SFD211867  
 PLAT 11895  
 PUD

# SITE PLAN

LOT 17, CATHEDRAL PINES SUBDIVISION FILING NO. 1  
 13795 HILDENSHIRE PLACE  
 COUNTY OF EL PASO, STATE OF COLORADO

RE: Lot 17, Filing 1 - 13795 Hildenshire Place  
Site, elevations, floor plan, and exterior colors

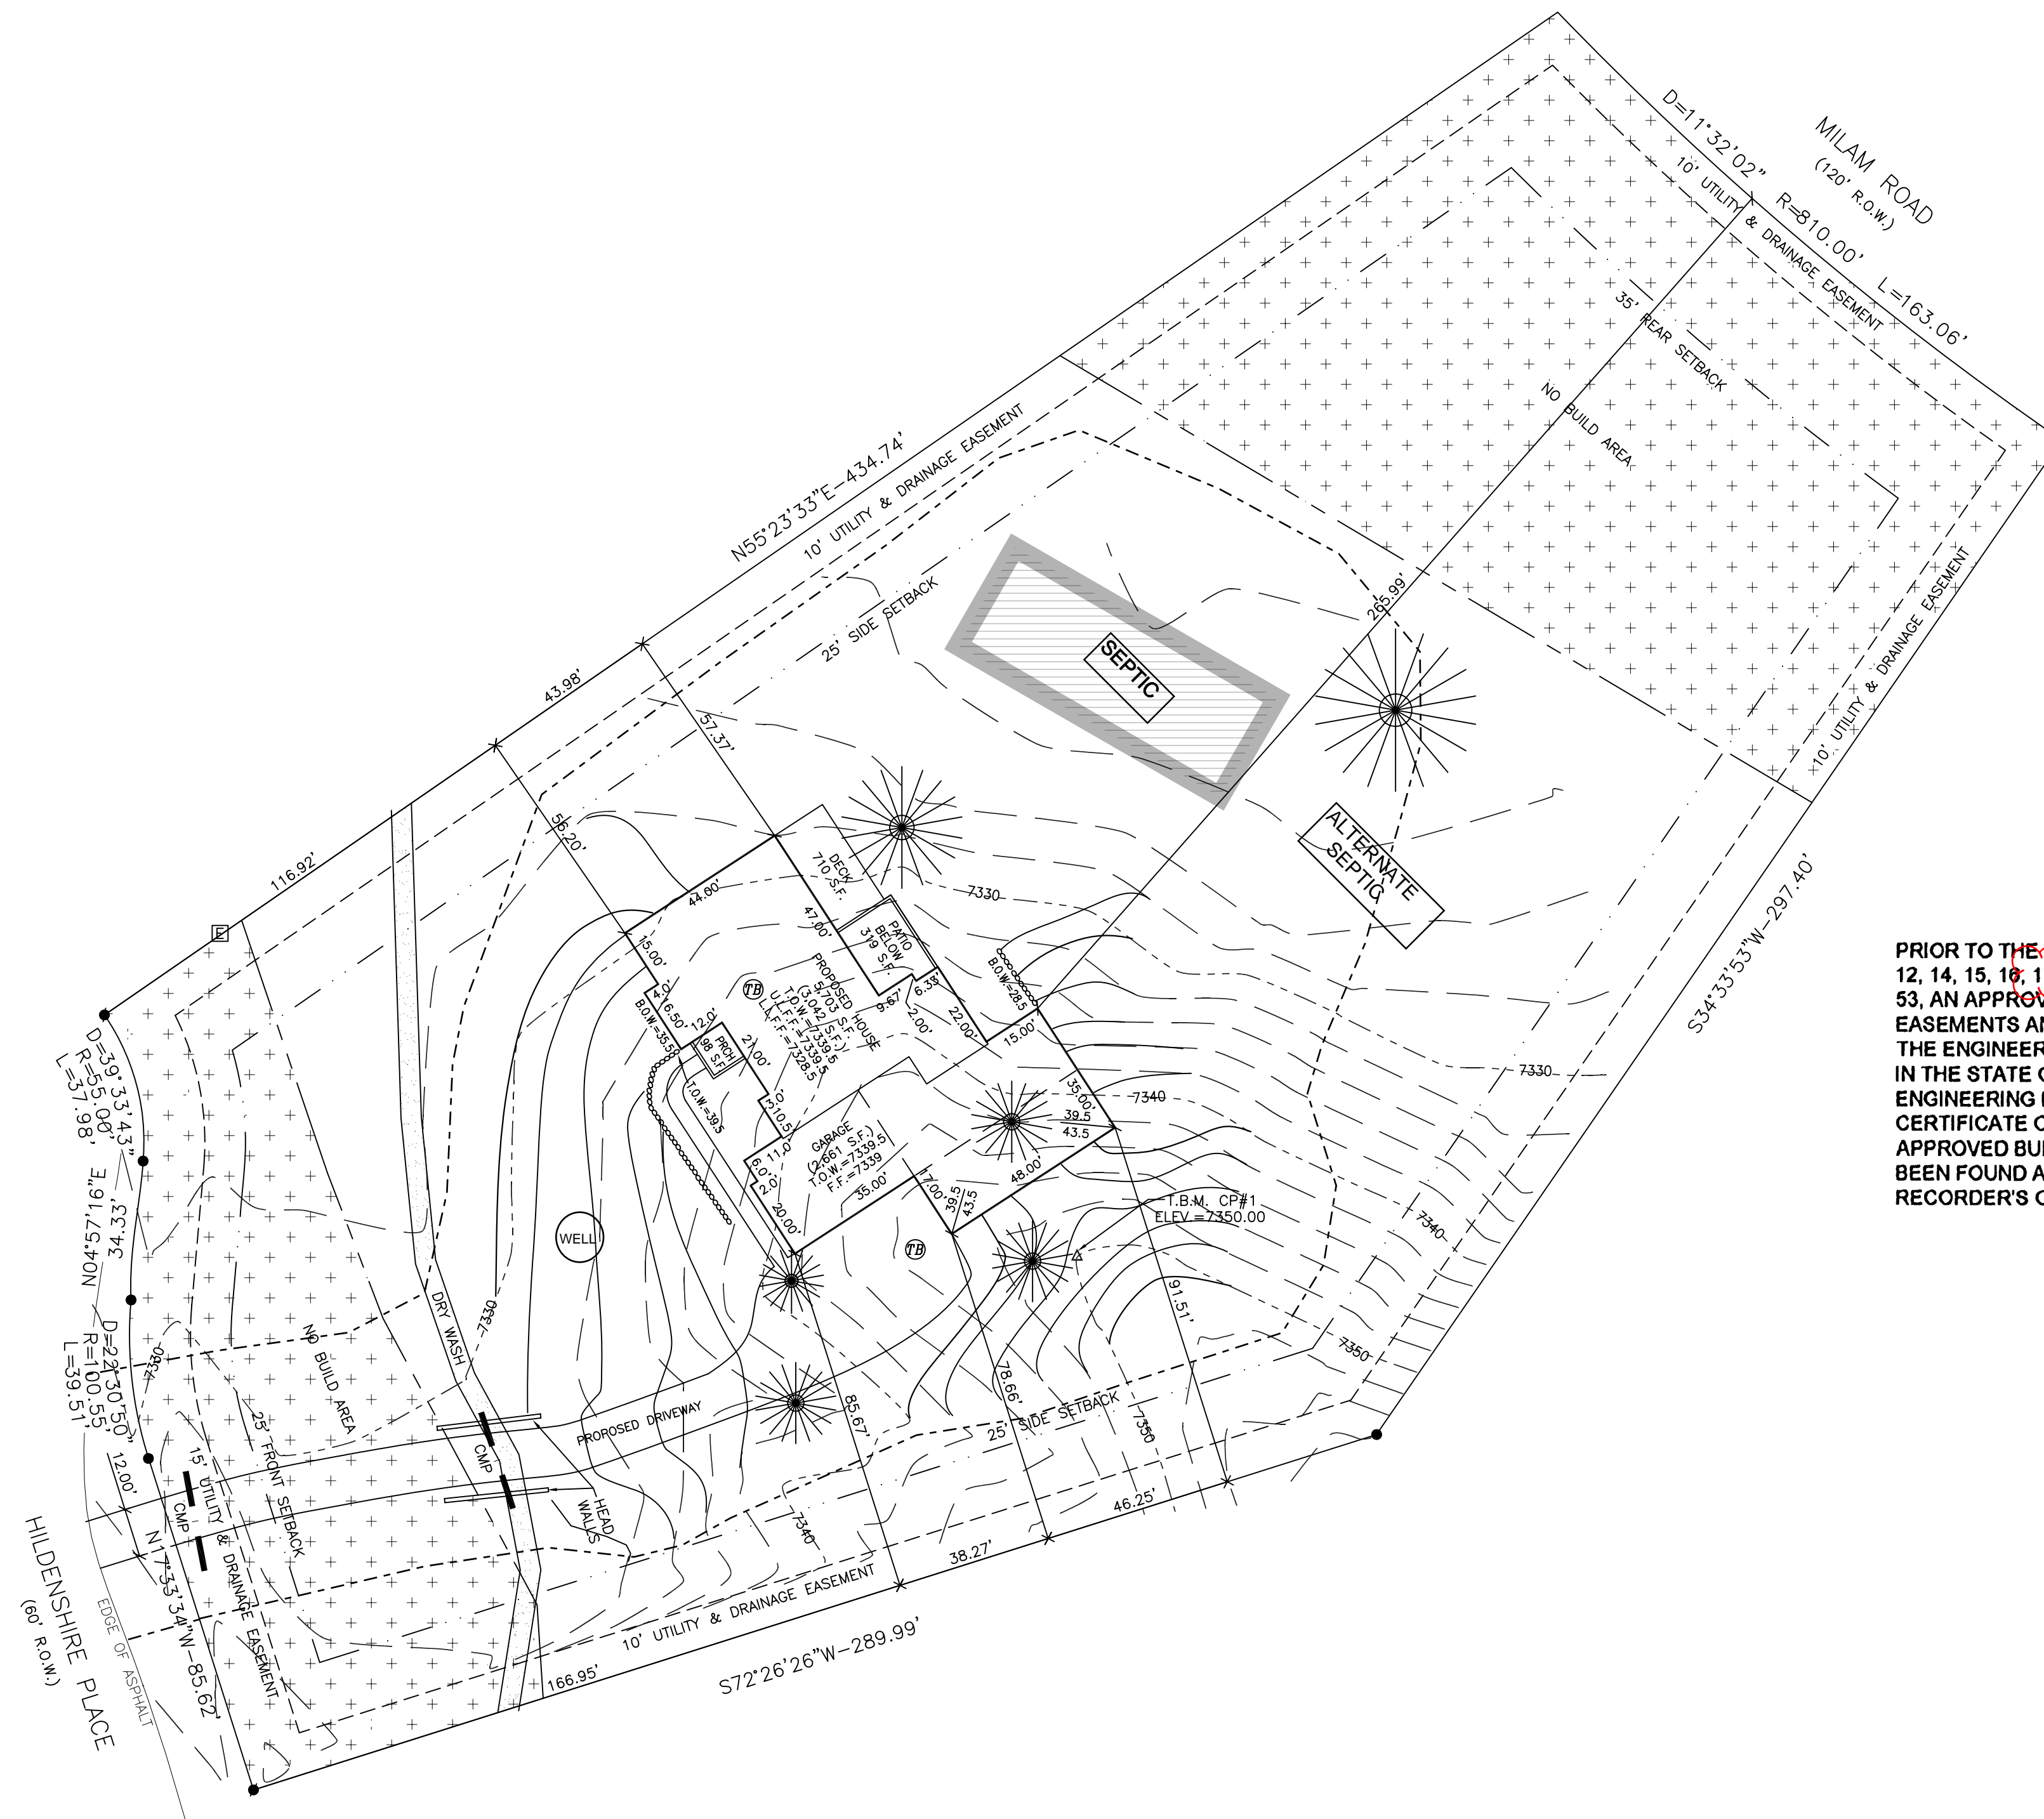
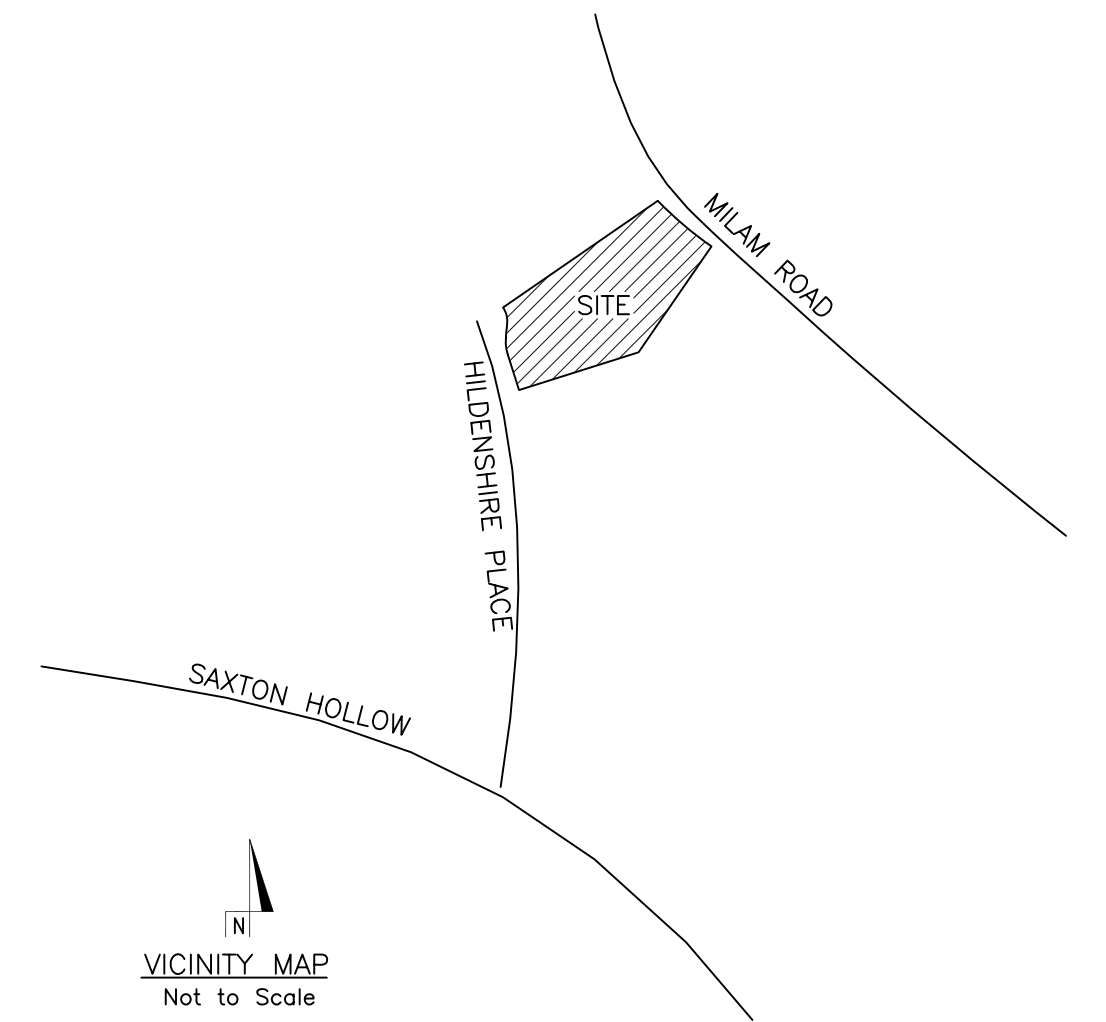
**DISAPPROVED**  
 Plan Review  
 12/06/2021 9:42:17 AM  
 dsdrangel  
 EPC Planning & Community  
 Development Department

**ENGINEERED STAMPED SITE PLAN REQUIRED**
